MEMORANDUM

Project: Peer Review of Trail Projects – Capital Crescent Trail and Silver Spring Green Trail

Re: Assessment of bicycle and pedestrian issues along the Purple Line corridor

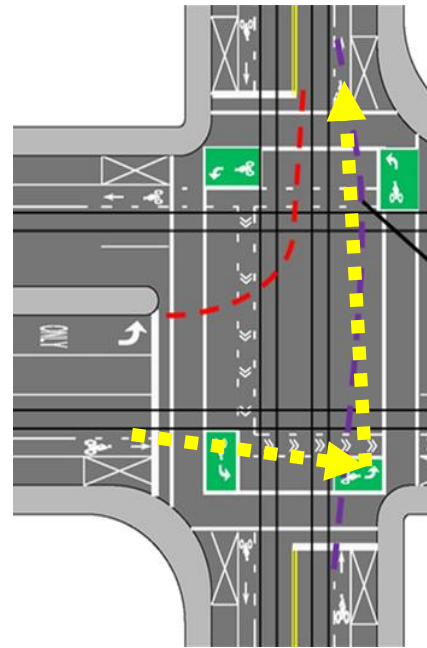
- In general, wherever bicycle use of a street with embedded tracks is legal, it should be expected and designed for. Use pavement markings and signage to facilitate safe track crossings. According to the AASHTO Bike Guide, the skew angle between the centerline of the tracks and the path of the bicycle should ideally be 90 degrees, but can be as low as 60 degrees to facilitate safe bicycle crossings. At all intersections, evaluate the angle at which each movement from each leg of the intersection (left, through, and right) crosses the tracks. If the crossing angle could be less than 60 degrees, use shared-lane markings to guide cyclists across tracks at an angle between 60 and 90 degrees. At some locations, it may be necessary to provide additional width for the cyclist to achieve this (see figure above).

If a 60-degree (or better) crossing is not possible, identify an alternative route and direct cyclists to it using signs. For instance, a two-stage left turn (aka crosswalk left) where the cyclists cross the street on the right side and wait in a bicycle box on the far side of the street to make a second crossing using the perpendicular crosswalk or the right hand travel lane to complete the left-turn maneuver (see dashed yellow line in figure at the right).

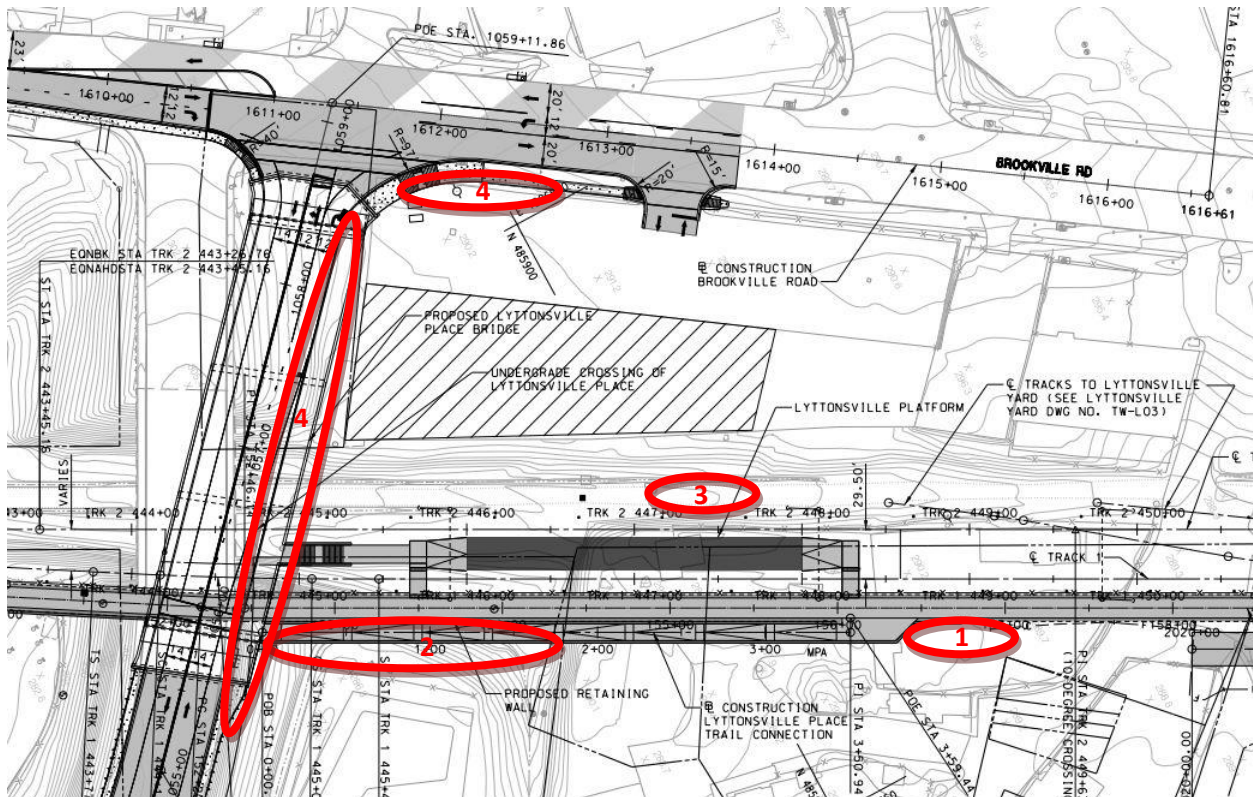
- Lyttonsville Bridge Cross Section:** The proposed bridge appears to provide 66 feet of travel space between the side walls/railings. To achieve the cross section

recommended by M-NCPPC without increasing the width of the bridge, TDG suggests the following cross section:

Use	Width (feet)
West Sidewalk	7
SB Bike Lane (including gutter pan)	6
SB Travel Lane	12
NB Travel Lane	12
NB Bike Lane (including gutter pan)	6
NB Bus Pullout	11
East Sidewalk/Shared-Use Path	12
Total	66

Because the tree buffer on the east side of Lyttonsville Place is not continued on the bridge, the east sidewalk/shared-use path can be 12 feet rather than 8 feet wide. Because it is primarily an access path to the Purple Line, not a through path, the 12 foot width can also accommodate bus shelters or benches for the waiting area and provides additional mixing capacity for the pedestrians and bicyclists accessing the CCT and Purple Line Station. The bike lanes on the bridge are 6 feet wide to provide bicyclists the opportunity for greater separation from adjacent buses when they are stopped to pick up/drop off transfer patrons.

Sligo Creek Trail

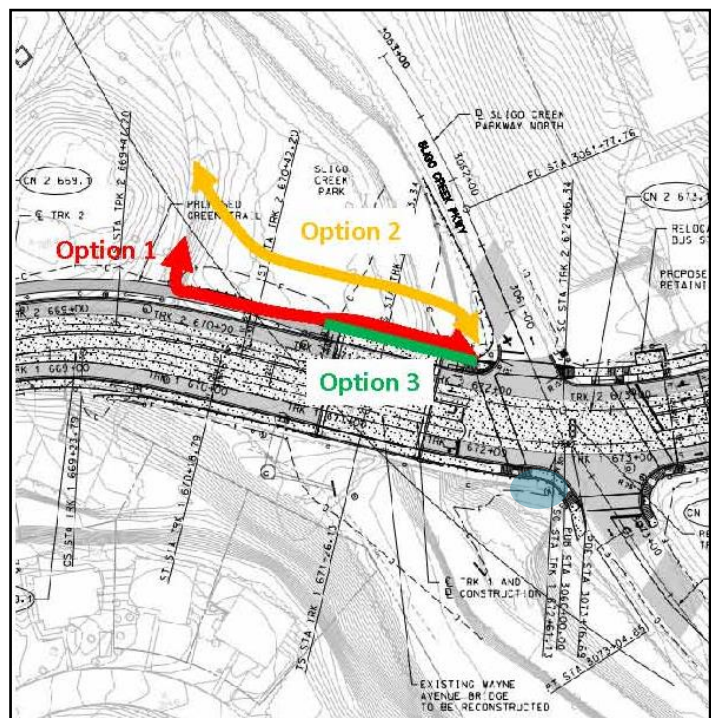
A number of issues exist with the current design of the Silver Spring Green Trail's linkage to the Sligo Creek Trail, and the trail's crossing of Piney Branch Road. They include the following:

1. A lack of sufficient trail width and buffer (not AASHTO standard) from the Sligo Creek Trail where it meets Wayne Avenue from the north to the bridge, across the replaced bridge, and to the intersection of Wayne Avenue and Sligo Creek Parkway. This section of the trail is essentially on the sidewalk today, and is unimproved by the Purple Line project.
2. A lack of improvement to the Sligo Creek Trail crossing of Wayne Avenue.
3. A lack of improvement to the Sligo Creek Trail on the south side of Wayne Avenue.
4. A lack of aesthetics in the design of the bridge as a gateway to Silver Spring and homage to the natural feature of Sligo Creek and Sligo Creek Park and Trail.

TDG concurs with the concerns raised by Planning Staff. Additionally, TDG is aware that the Sligo Creek Trail was designed many years ago. In its current condition in this area, it is substandard in width, and it appears that the Purple Line project is not bringing the parts of the trail impacted by the project up to current standards. It is a best practice to have every capital transportation project improve the other transportation facilities in its area of impact. The Sligo Creek trail is expected to be a major feeder of bicycle and pedestrian traffic to the Purple Line, thus the Purple Line will result in increased trail traffic which the project should accommodate. Moreover, improving a portion of the Sligo Trail will encourage its use for Purple Line access and help ensure that Purple Line ridership projections are met.
